Hyattsville Accessibility Transition Plan

Heurich Playground

Heurich Playground - Hyattsville Transition Plan

Address: Nicholson Street (near Ager Road)

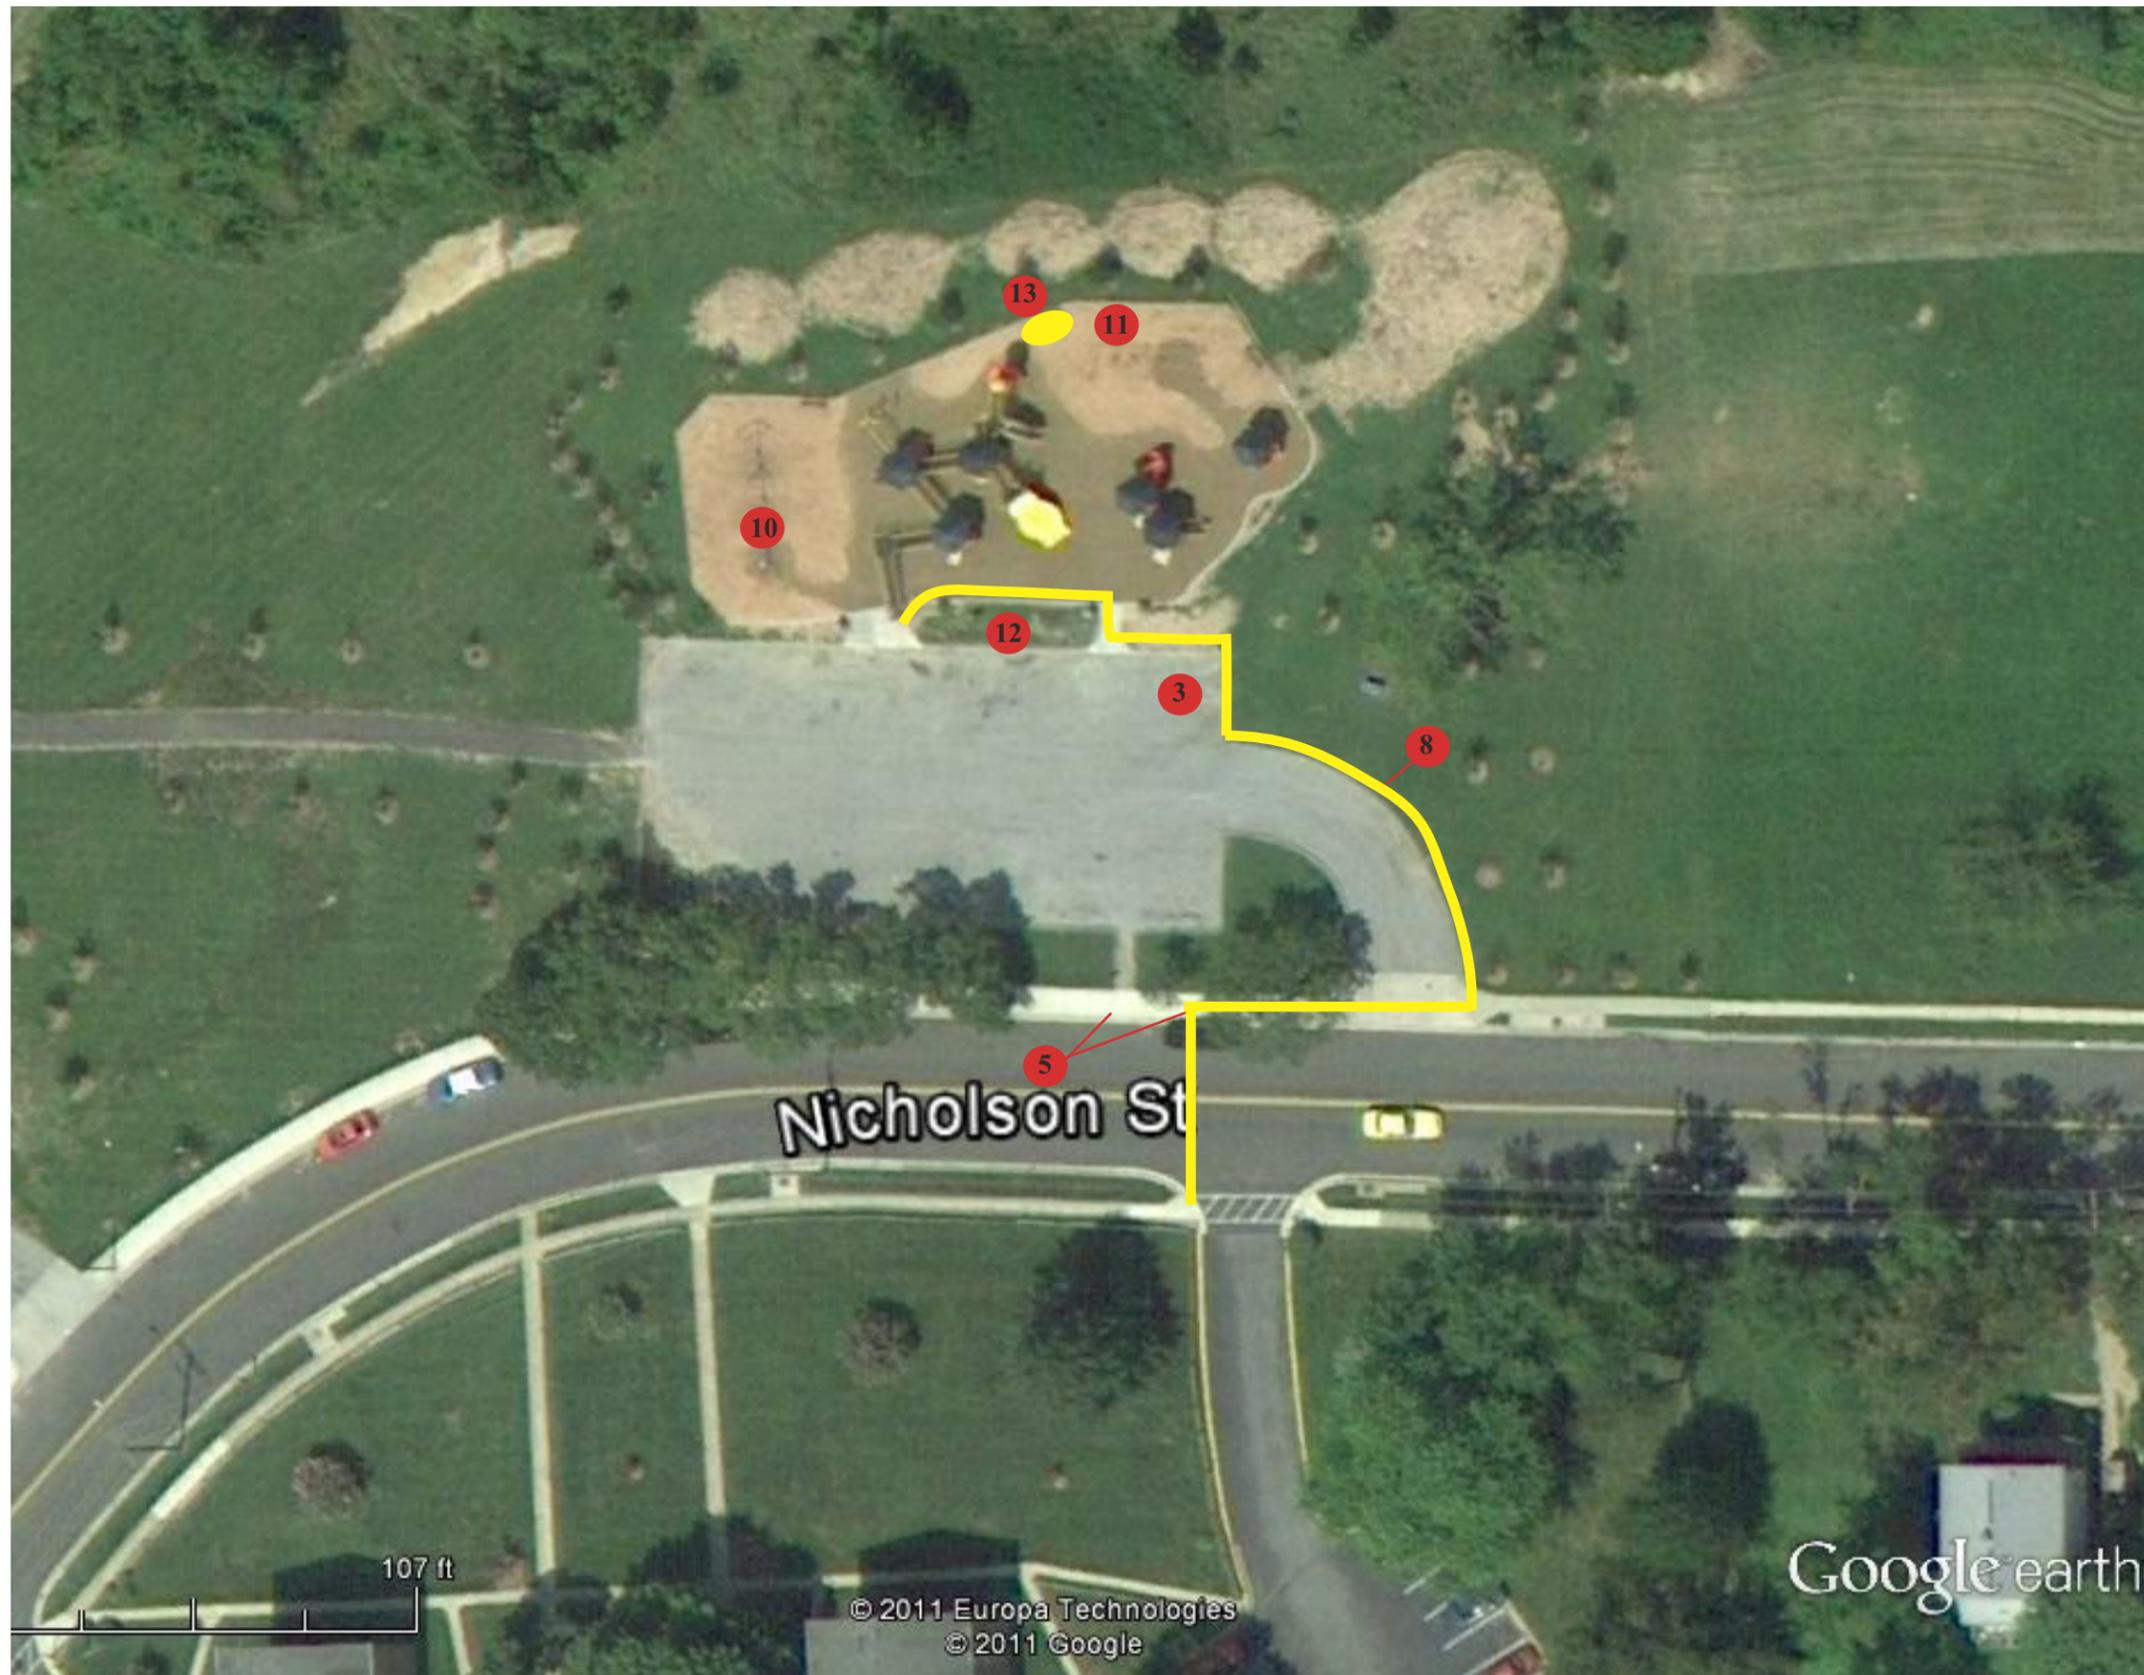
2010 Standards Citation	Description/Issue/Requirement	Non-Complying Item	Photos	Proposed Solution	Suggested Priority	Projected Cost Hyattsville	Projected Date	Action and Date
1									
2		Accessible Route from Parking to Tot Play Area Entry:							
3	208.2,	Parking is provided for visitors. Therefore, accessible parking must be provided for visitors.	There are no markings for parking spaces in the parking lot so the number of spaces can not be ascertained. Therefore, a total of required accessible spaces can not be ascertained.	2564	We estimate 24 spaces could be accommodated in the parking lot. Provide one accessible van space with accessible signage.	11	\$700		
4	*208.2.4,	At least one van accessible parking space must be provided for every 6 accessible parking spaces.	No accessible spaces have been provided. Therefore, the number required to be van accessible can not be ascertained.	2564	Corrected with solution for item 3	11	see item 3

5	206.1, 406.1	Slope of curb ramp cannot exceed 8.33%.	The curb ramp at the sidewalk, west of the park entry has a slope of 12.6%.	2520, 2521	Remove existing curb ramp with flared sides and gutter. Construct new Type B curb ramp several feet to the east of the existing location, to align with existing ramp across the street. New curb ramp to have an 8.33% maximum slope and a 2% maximum cross- slope. Flared sides must be no more than 1:12. Repair portion of gutter to have counter slope no more than 5%. Provide "no parking" sign. Paint a crosswalk to opposite curb ramp. .	11	\$6,625		
6	206.1, 406.4	Landings shall be provided at the tops of curb ramps. The landing clear length shall be 36 inches minimum and the flared sides shall be no greater than 1:10 (10%). In alterations, if there is no landing, the flared sides must be no greater than 1:12 or 8.33%.	At the curb ramp at the sidewalk west of the park entry, there is no landing. The flared sides of the curb ramp are 20.9% and 24.3%.	2526, 2527, 2528, 2529	Corrected with solution for item 5	11	see item 5

7	206.1, 406.2	Curb ramp is not a parallel type. Therefore, the gutter cannot counter slope more than 5%.	The gutter to the curb ramp at the sidewalk at the park entry has a counter slope of 6.0%.	2530, 2531	Corrected with solution for item 5	11	see item 5		
8		While not specifically a barrier, it may not be advisable to have a traffic lane as part of the accessible route if cars can not easily see wheelchair users.	The accessible route up the entry drive has a curve in it and wheelchair users on this drive may not be seen by entering traffic. It is recommended to provide a sidewalk for the accessible route from the public sidewalk to the Tot Play Area.	see site map	Recommend providing an accessible route from public sidewalk to the Tot Play Area that does not require traveling in the entry drive. This can be located on the outside perimeter of the entry drive.	25	\$4,200

Heurich Playground - Hyattsville Transition Plan								
Address: Nicholson Street (near Ager Road)								
2010 Standards Citation	Description/Issue/Requirement	Non-Complying Item	Photos	Proposed Solution	Suggested Priority	Projected Cost Hyattsville	Projected Date	Action and Date
9	Play Areas:							
10	*240.2.1.1,	Where ground level play components are provided, at least one of each type shall be on an accessible route.	This is a playground. There are (12) twelve different types of ground level play experiences required to be on an accessible route. Currently, most of the required ground level types are located on an accessible route, but one of each type is not provided. Missing on the accessible ground level route is a child size swing.	7107	The swing set is present, but the child size swing located at the accessible surface have been removed. Replace one swing above existing accessible surface.	11	\$250

11	*240.2.1.1, *1008.4.4	Where ground level play components are provided, an entry point 11" to 24" above the ground shall be provided at the accessible components.	On the swings, the entry point to the baby size swing equipment is 35 1/2" above the ground.	2469, 7083, 7084	Lower existing baby size swing seat to position seats between 11" and 24" above the ground.	11	\$200	
12	216.3, 703.5.6	Informational and directional signage must have a character height of 5/8" minimum.	Characters on the playground signage are 1/2".	2565, 2566, 2572, 2573	Replace signage	17	\$1,000	
13	206.1, 302.1	Accessible route must be firm, stable, and slip resistant.	The park bench seating is not accessible by a paved surface.	2464, 2513, 7082	Install a new bench seating at playground on accessible surface with adjacent wheelchair seating or extend existing accessible surface around existing bench.	25	\$1,480	
14	226.1, 302.1	Benches are provided. Wheelchair spaces must be provided with the benches. The clear ground space must be stable, firm, and slip-resistant.	In the playground, the wheelchair space adjacent to the bench is not paved.	2464, 2513, 7082	Corrected with solution for item 13	25	see item 13
